URGENT: Medical Device Recall Notification [Expansion of Affected Units]
AFFECTED DEVICE: Alaris™ Pump Module Model 8100

April 15, 2019

Figure 1a: Pump Module with door open showing the front of the bezel

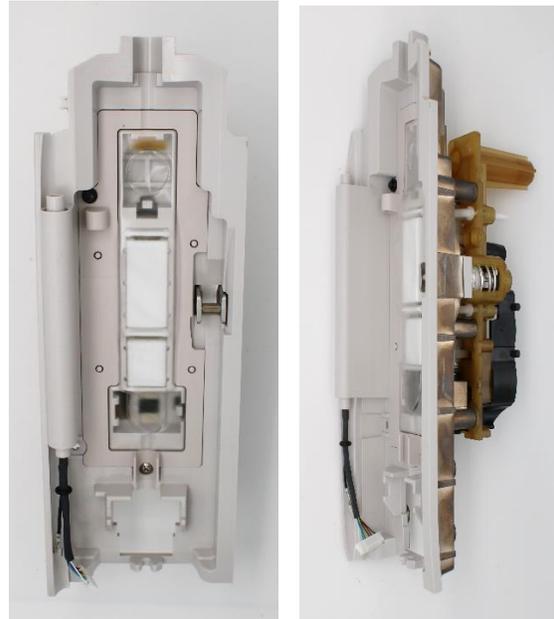
The component of the Alaris Pump module that is the subject of this recall is the bezel assembly (*Attachment A, Figure 1*), and the issue involves potential separation of the bezel posts (*Attachment A, Figure 2*). The bezel has 6 posts that connect the pumping mechanism frame to the bezel assembly and are critical to proper performance of the pump. BD's ongoing investigation has determined that the bezel manufacturing process for the FR-110 plastic may have resulted in its weakening. A bezel with weakened plastic may, over time, lead to separation of the bezel post (recall issue) as well as other damage to the bezel (i.e. external cracking). The separation of one or more bezel posts is a potential safety concern and, therefore, BD is initiating this voluntary recall.
